The Commission has issued the enclosed Amendment No. 11 to Provisional Operating License No. DPR-22 for the Monticello Nuclear Generating Plant. This amendment includes Change No. 19 to the Technical Specifications and is in response to your requests dated August 16, 1974, and July 1, 1975.

MONTICELLO NUCLEAR GENERATING PLANT

Amendment No. 11
License No. DPR-22

CHANGE NO. 19 TO THE TECHNICAL SPECIFICATIONS

FIGURE 3.6.1 Change in Charpy V Transition Temperature versus Neutron Exposure

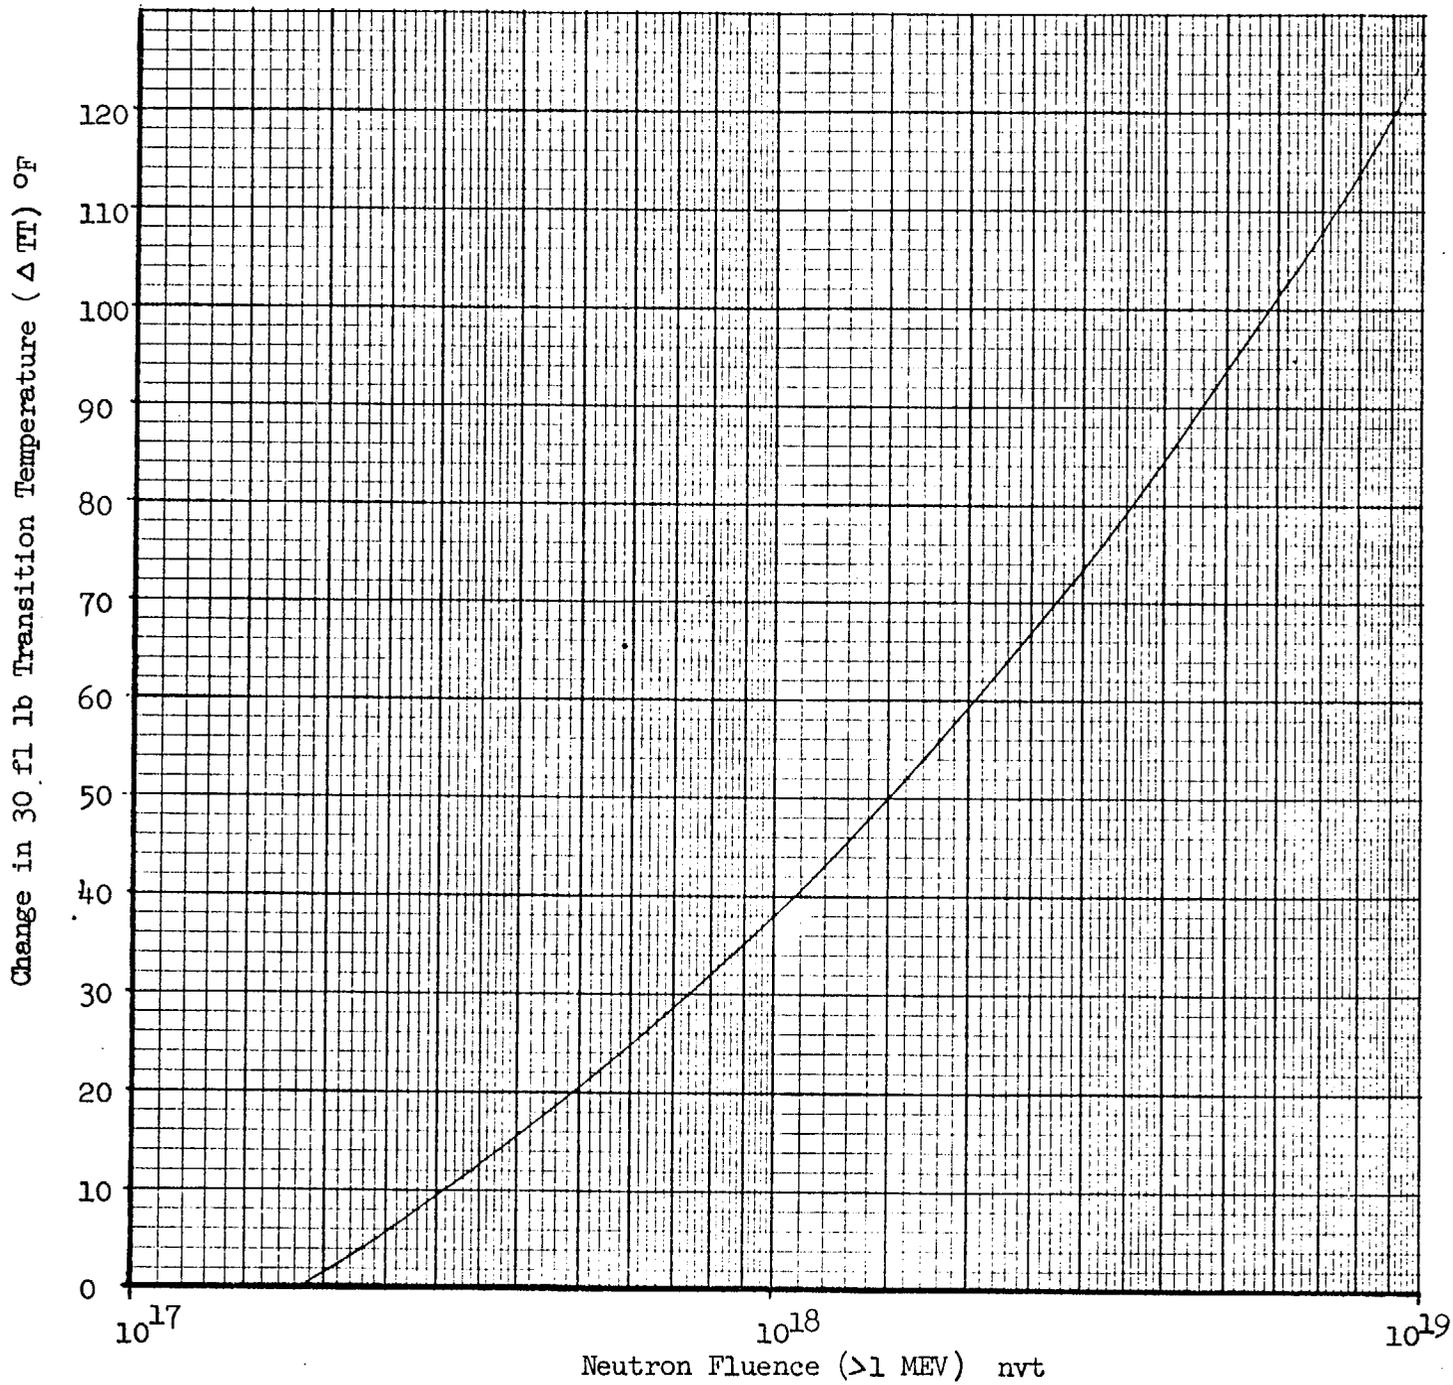
1. During in-service hydrostatic or leak testing, the reactor vessel shell temperatures specified in 4.6.B.1 shall be at or above the higher of the temperatures shown on the two curves of Figure 3.6.2 where the dashed curve, "RPV Beltline Region," is increased by the expected shift in RT_{NDT} from Figure 3.6.1.

A relationship between neutron fluence and change in Charpy V notch test 30 ftlb transition temperature has been developed for SA302B/SA533 steel based on at least 35 experimental data points as shown in Figure 3.6.1. In turn this change in transition temperature can be related to a change in the temperature ordinate shown in Figure G 2110-1 in Appendix G of Section III of the ASME Boiler and Pressure Vessel Code.

Figure 3.6.1 will be conservative for the Monticello reactor vessel. Reactor vessel material samples are provided, however, to verify the relationship expressed by Figure 3.6.1. Three sets of mechanical test specimens representing the base metal, weld metal, and weld heat affected zone (HAZ) metal have been placed in the vessel and can be removed and tested as required. These samples will receive neutron exposure more rapidly than the vessel wall and therefore will lead the vessel in integrated neutron flux exposure. An analysis and report will be submitted to the Commission on all such surveillance specimens removed from the reactor vessel in accordance with 10CFR50, Appendix H. These reports shall include the information specified in ASTM E-185-66, "Recommended Practices for Surveillance Tests on Structural Materials in Nuclear Reactors," and information obtained on the level of integrated fast neutron irradiation received by the specimens and actual vessel material.

Predicted changes in NDT temperature as a function of neutron fluence are given in Figure 3.6.1. of the Technical Specifications. This curve is based on 35 data points from tests on SA 302B and SA 533B steel. It agrees with our prediction for SA 533B steel with 0.15% copper. The percent of copper in the Monticello reactor vessel plate material from the beltline region has not been determined.

FIGURE 3.6.3 Minimum Temperature versus Pressure for Mechanical Heatup or Cooldown Following Nuclear Shutdown

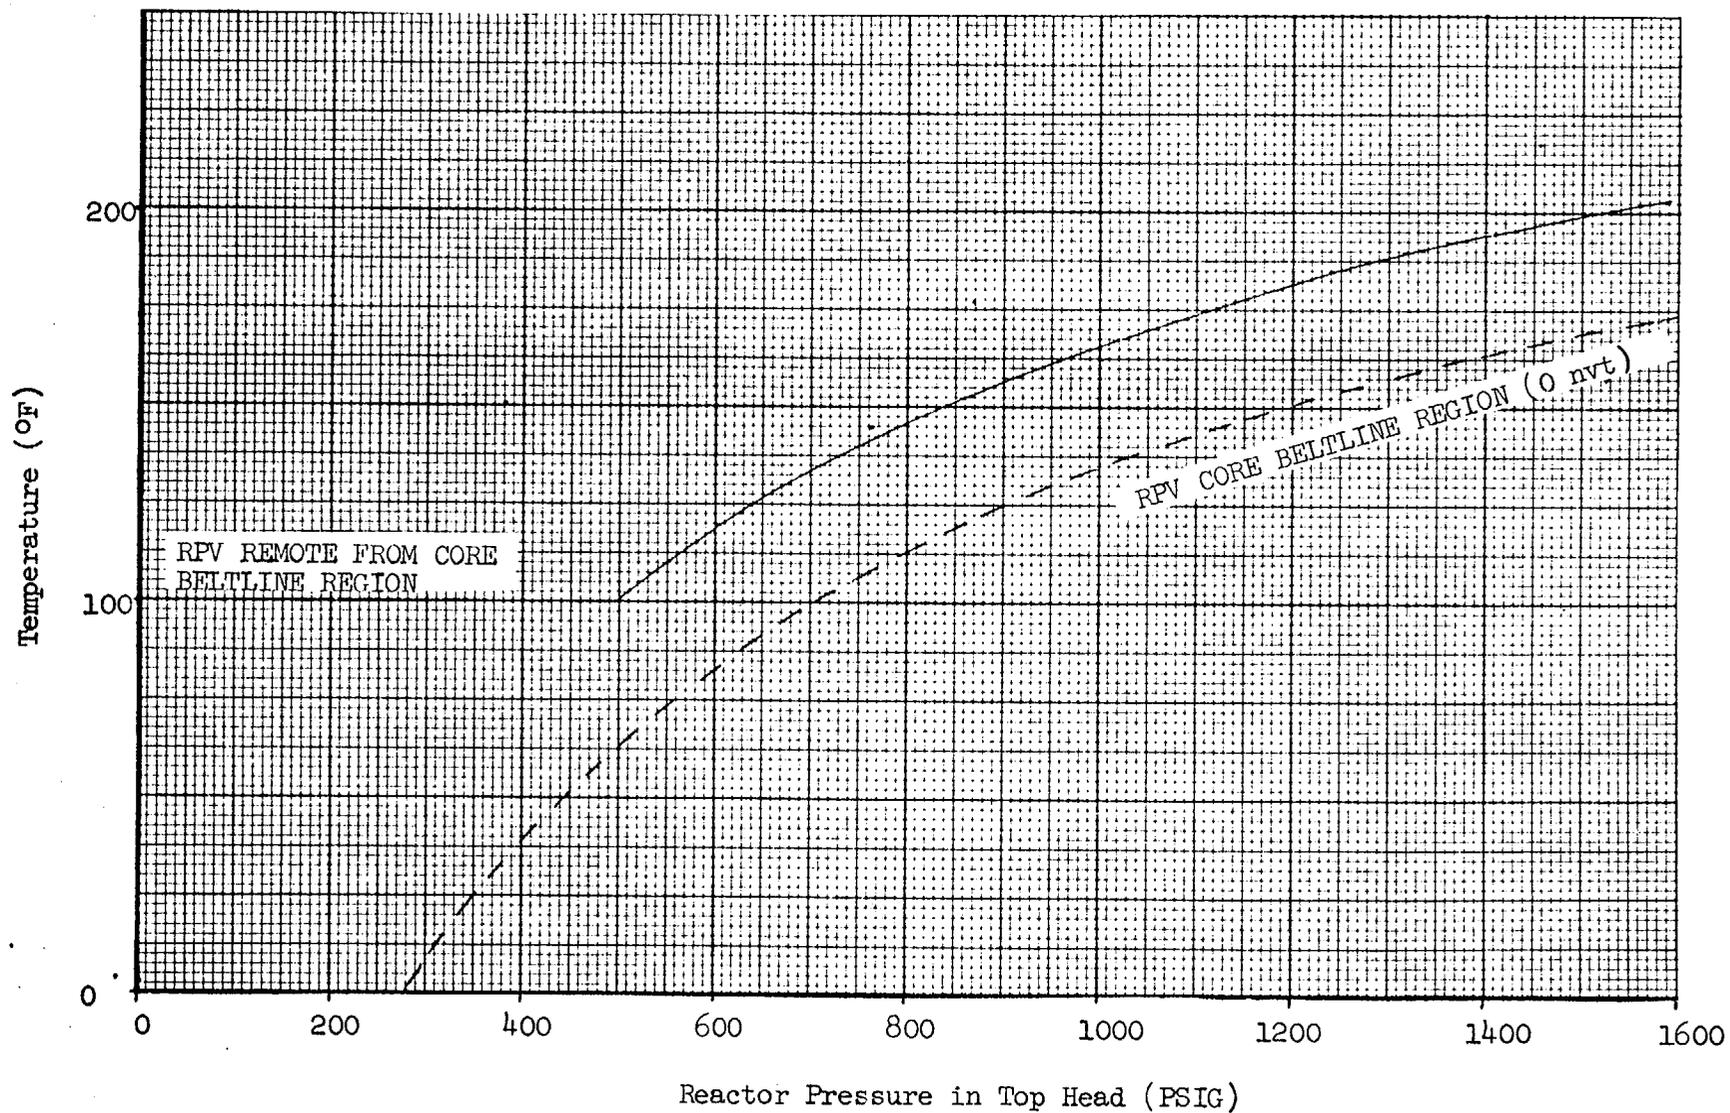
2. During heatup by non-nuclear means (except with the reactor vessel vented), cooldown following nuclear shutdown, or low level physics tests the reactor vessel shell and fluid temperatures specified in 3.6.A shall be at or above the higher of the temperatures of Figure 3.6.3 where the dashed curve, "RPV Beltline Region," is increased by the expected shift in RT_{NDT} from Figure 3.6.1.

FIGURE 3.6.4 Minimum Temperature versus Pressure for Core Operation

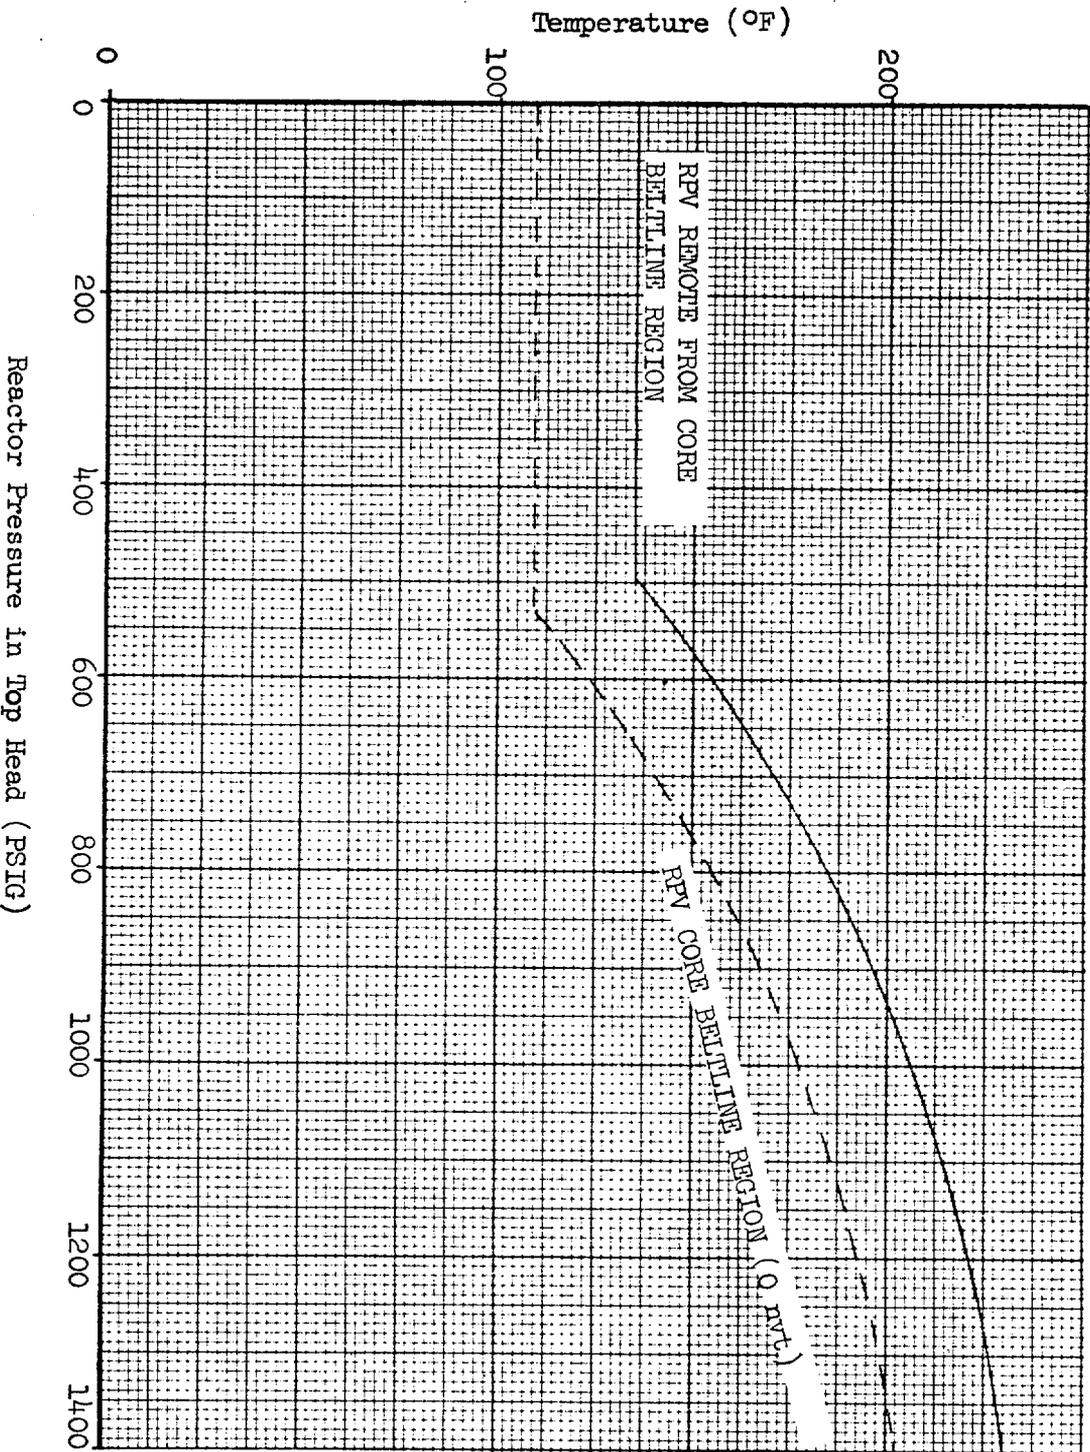
3. During all operation with a critical reactor, other than for low level physics tests or at times when the reactor vessel is vented, the reactor vessel shell and fluid temperatures specified in 3.6.A shall be at or above the higher of the temperatures of Figure 3.6.4 where the dashed curve, "RPV Beltline Region," is increased by the expected shift in RT_{NDT} from Figure 3.6.1.

Figure 4.8. Off-Gas Storage Tank Gross Activity Limits

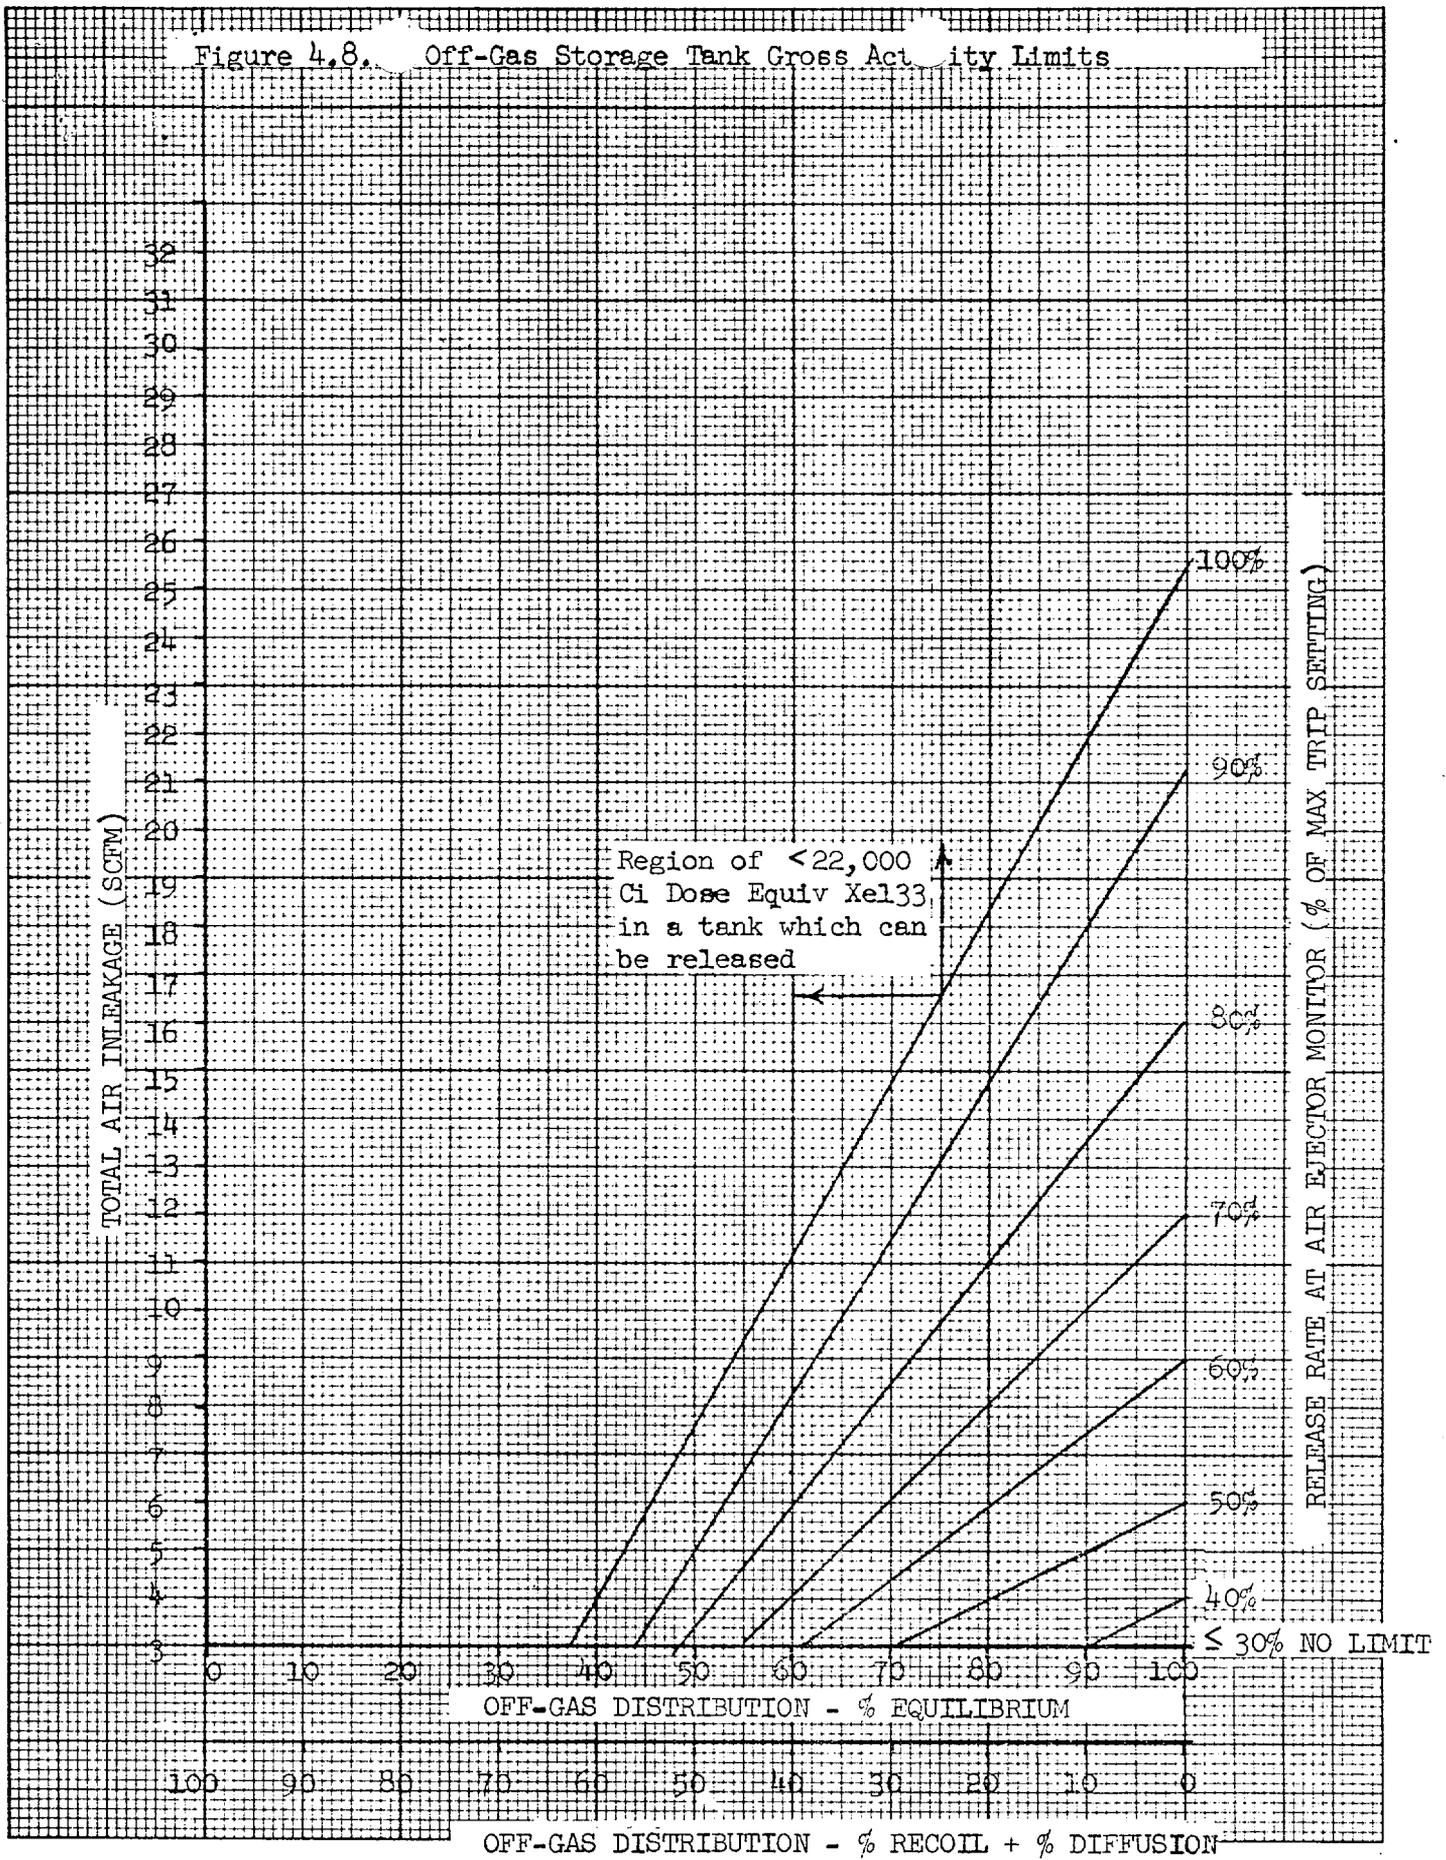
Calculations have been performed to determine the relationship between steam jet air ejector off-gas activity and composition and condenser air inleakage. These calculations were used to determine the curves presented in Figure 4.8.1. The results of the weekly measurement of condenser air inleakage and the average daily air ejector off-gas release rate are used in conjunction with the most recent off-gas isotopic analysis to determine if the maximum permitted Xe-133 dose equivalent tank radioactivity contents may be exceeded. Daily analysis is adequate to determine that if the maximum amount of gross activity in a decay tank may be exceeded, action can be taken to reduce the radioactivity to a level below the specified limit.

Item No. 5 of the July 1 application proposes (1) revisions to Specifications 3.8.E.2, 3.8.E.3, 4.8.E.2 and 4.8.E.3, (2) incorporation of a new Figure 4.8.1, "Off-Gas Storage Tank Gross Activity Limits," and (3) revisions to 3/4.8.E Bases to reflect the changes in item (1). The changes in item (1) are discussed individually below.

This change consists of incorporating Figure 4.8.1 into the Technical Specifications which we found to be acceptable in (c) above.
